# Access Compliance Report

## Public Rights-of-Way

### (Curb Ramps)

Intersection ID: 16738	Main Street: BEVERLY_DR	Cross Street: SHERWOOD_AV	Location: NE
ADA ID: 8AC071AEDC52	Ramp Type: PerpDiag	Initial Pass/Fail: Fail	Overall Compliance: No
Severity Score: 33.75			
Codes/Mitigation Info/Possible Solution		Field Measurements/Component Compliance

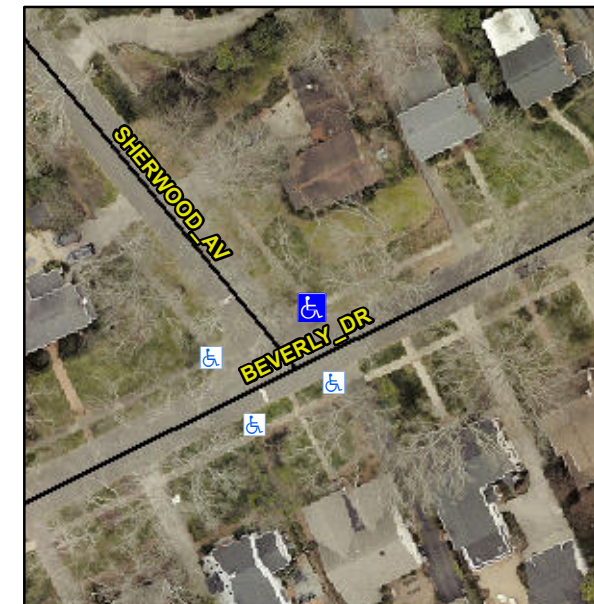
**Remove & Replace Curb Ramp With Two New Directional Ramps or Equivalent.**

**R304.5.1, R304.2.2, R304.5.3**

Compliance	Description	Data	Compliance	Description	Data
N/A	Ramp Length (in)	64.5	No	Ramp Slope (%)	11.0
No	Ramp Width (in)	43.5	No	Ramp XSlope (%)	5.6
N/A	Flare Type LT	N/A	N/A	Flare Type RT	N/A
N/A	Flare Slope LT (%)	N/A	N/A	Flare Slope RT (%)	N/A
N/A	Flare Traversable LT?	N/A	N/A	Flare Traversable RT?	N/A
N/A	Landing Length (in)	N/A	N/A	DWS Provided?	N/A
N/A	Landing Width (in)	N/A	N/A	DWS Contrast?	N/A
N/A	Landing Slope (%)	N/A	N/A	DWS Length (in)	N/A
N/A	Landing X Slope (%)	N/A	N/A	DWS Full Width?	N/A
N/A	Landing Curb? (Y/N)	N/A	N/A	DWS Offset (in)	N/A
N/A	Shared Landing?	N/A			
N/A	Gutter Ponding?	N/A	N/A	Gutter Slope (%)	N/A
N/A	Gutter Lip Ht (in)	N/A	N/A	Gutter X Slope (%)	N/A
N/A	Painted X Walk1?	No	N/A	Painted X Walk2?	No
	X Walk 1 Direction	To W		X Walk 2 Direction	To S
N/A	X Walk 1 Width (in)	N/A	N/A	X Walk 2 Width (in)	N/A
	X Walk 1 Slope (%)	2.5		X Walk 2 Slope (%)	2.2
	X Walk 1 X Slope (%)	4.0		X Walk 2 X Slope (%)	2.7
